Wheel Bolt Replacement Requirement - Change from Wheel Bolts with Aluminum Washers to Wheel Bolts with Steel Washers (40/26)

Model Line: **Cayman/Boxster (981/982)
911 (991/992)
Taycan (Y1A/Y1B/Y1C)
Panamera (970/971)
Macan (95B)
Cayenne PA (92A/9YA/9YB)**

Concerns: **Replacement requirement for wheel bolts with aluminium washers**

Visual differentiation of wheel bolts

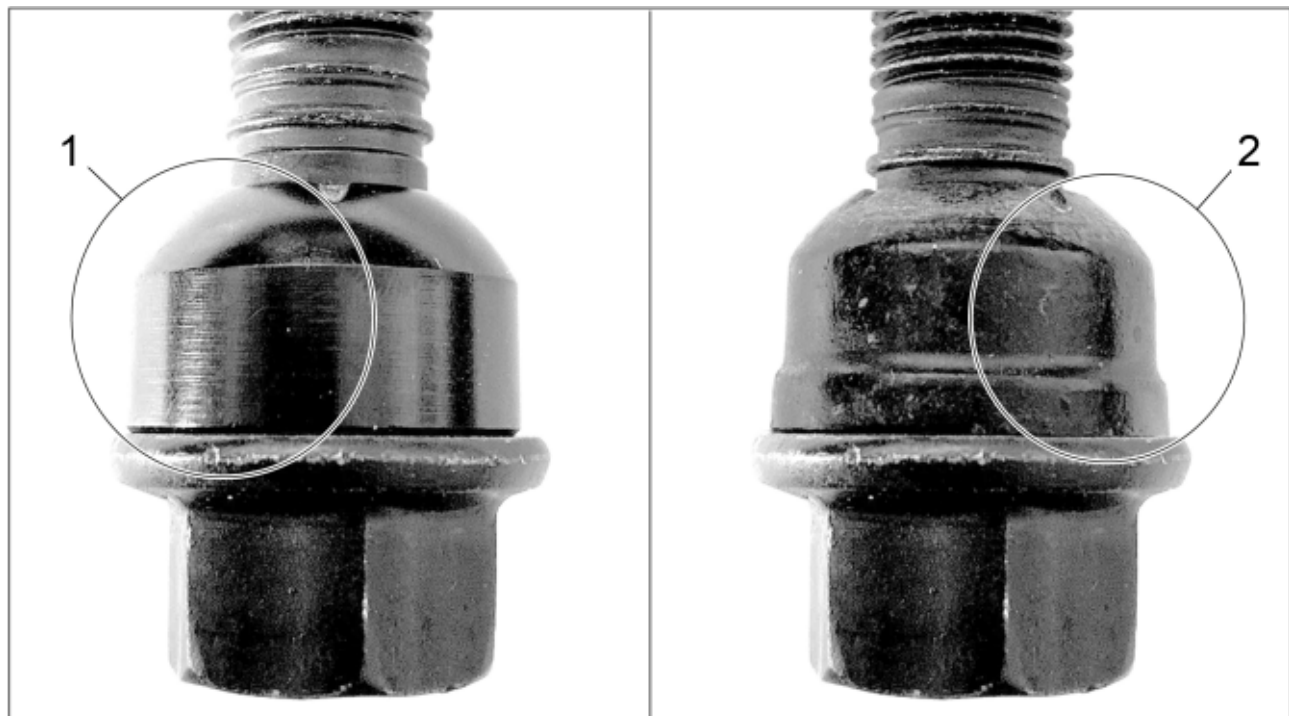
Cause: **As part of a material change due to long procurement times for aluminium washers, an interim change has been made to a wheel bolt variant with a steel washer.**
As a result, wheel bolts with aluminium washers can sometimes no longer be supplied.

Action: If wheel bolts with aluminium washers are required to be replaced and parts are not available, replace **all** wheel bolts with aluminium washers on the vehicle with wheel bolts with steel washers. ⇒ *Visual differentiation of wheel bolts*

It must be ensured that there is no mixed installation of wheel bolts with aluminium washers and wheel bolts with steel washers on the vehicle.
